Office Action Summary

DETAILED ACTION

Claims 1, 2, 5-9, 11, 12 and 14-17 are rejected under 35 U.S.C. 102(b) as being anticipated by Koppelkamm et al. (US Patent 5,806,428).

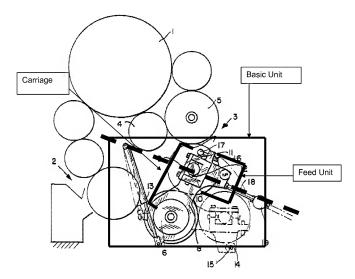
Regarding claims 1 and 11, Koppelkamm et al. teaches a first mating roller (5), a second mating roller (6) having a circumferential surface defining a second mating roller tangential direction, an engagement roller (7) for engaging and/or disengaging with or from the first mating roller and for engagement with the second mating roller, a basic unit, with which the roller can be moved to or away from the first mating roller in the circumferential direction of the second mating roller (refer to figure on page 6 of detailed

action), wherein the basic unit connected to the roller (7) via the feed unit (refer to figure on page 6 of detailed action), the basic unit is for guiding the roller together with the feed unit in the circumferential direction of the second mating roller and is adjustable in position for moving the engagement roller (7) in a direction parallel to the second mating roller tangential direction (note: the limitation is functional language, therefore the basic unit in the prior art has the capability of performing the intended function) and is in contact with the second mating roller, a feed unit (refer to figure on page 6 of the detailed action), the roller (7) being mounted on the feed unit and the feed unit being positionable in a bisecting line position with a rotational axis of said roller mounted on a bisecting line that bisects an angle between said first mating cylinder and said second mating cylinder (refer to figure on page 6 of the detailed action) and the feed unit for generating engaging pressure with which, in said bisecting line position, wherein the roller acts approximately uniformly on said first mating cylinder and said second mating cylinder such that a nip ratio between said first mating cylinder and said second mating cylinder is approximately equal (note: the limitation is functional language, therefore the feed unit in the prior art has the capability of performing the intended function).

Regarding claim 3, Koppelkamm et al. teaches wherein the basic unit is adjustable in parallel to a tangential direction of the second mating roller for deflecting the feed unit from the bisecting line position to vary the nip ratio between the first mating cylinder (3) and the second mating cylinder (1) to generate a greater nip width

between one of the first mating cylinder and said roller and the second mating cylinder and the roller (note: the limitation is functional language, therefore the basic unit in the prior art has the capability of performing the intended function).

Regarding claims 7 and 17, Koppelkamm et al. teaches wherein the roller is mounted in a carriage (refer to figure on page 5 of the detailed action).

Regarding claim 14, Koppelkamm et al. teaches a feed unit, with which an engaging pressure can be generated on at least one of the mating rollers (refer to figure above).

Page 10

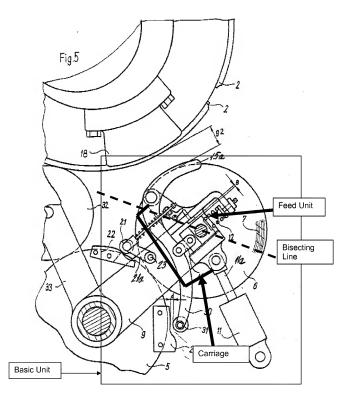
Regarding claims 1 and 11, Heimlicher teaches mating rollers (1,5,32), an engagement roller (7) for engaging and/or disengaging with or from the first mating roller and for engagement with the second mating roller (Abstract and Column 5. Lines 15-60), a basic unit (refer to figure on page 10) with which the roller (7) can be moved to or away from the first mating roller (1) in the circumferential direction of the additional mating rollers (5, 32 and refer to figure 10), a feed unit, the roller (7) being mounted on the feed unit (refer to figure on page 10 of the detailed action), feed unit being positionable in a bisecting line position (refer to figure on page 10 of the detailed action) with a rotational axis of the roller mounted on a bisecting line that bisects an angle between the first mating cylinder and the second mating cylinder, the feed unit for generating engaging pressure with which, in the bisecting line position, the roller acts approximately uniformly on the first mating cylinder and the second mating cylinder such that a nip ratio between the first mating cylinder and said second mating cylinder is approximately equal (note: the limitation is functional language, therefore the basic unit in the prior art has the capability of performing the intended function), a basic unit connected to the roller via the feed unit (refer to figure on page 10 of the detailed action), the basic unit for guiding the roller together with the feed unit in the circumferential direction of the second mating roller, with the base unit the roller can be moved to or away from the first mating roller in the circumferential direction of the second mating roller whereby the roller may be maintained in contact with said second

Regarding claims 7 and 17, Heimlicher teaches wherein the roller (7) is mounted in a carriage (refer to figure on page 10).

Regarding claim 14, Heimlicher teaches a feed unit (refer to figure on page 9), with which an engaging pressure can be generated on at least one of the mating rollers (Abstract and Column 5, Lines 15-60).

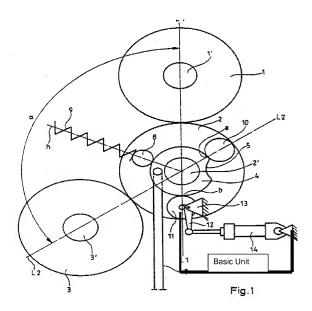
Regarding claim 8, Jahn teaches guiding the roller (2) in the circumferential direction of the second mating roller (1) in the state in which the roller is engaged with the second mating roller, and moving the roller in a direction tangential to an outer surface of the second mating roller (Column 4, Lines 13-21, Figures 1,4).

Regarding claim 9, Jahn teaches wherein the roller (2) is continuously in contact with the second mating roller (element 1 and Figures 1, 4).

Regarding claim 10, Jahn teaches wherein a nip, a nip ratio or the engaging pressure is set in the state in which the two mating rollers are engaged by a step of moving the roller in a direction tangential to an outer surface of the second mating roller (Figure 1).

Regarding claim 11, Jahn teaches a first mating roller (3), a second mating roller (1) having a circumferential surface defining a second mating roller tangential direction, an engagement roller (2) and for engagement with the second mating roller (figures 1 and 4), a basic unit (refer to figure on page 13 of the detailed action) with which the roller (2) can be moved to or away (Figure 5) from the first mating roller (3) in the circumferential direction of the second mating roller, wherein the basic unit (refer to figure on page 13 of the detailed action) being adjustable in position for moving the engagement roller (2) in a direction parallel to the second mating roller tangential direction (Column 3, Lines 65-68 and Column 4, Lines 12).

Regarding claim 14, Jahn teaches a feed unit (refer to figure on page 13 of the detailed action), with which an engaging pressure can be generated on at least one of the mating rollers.
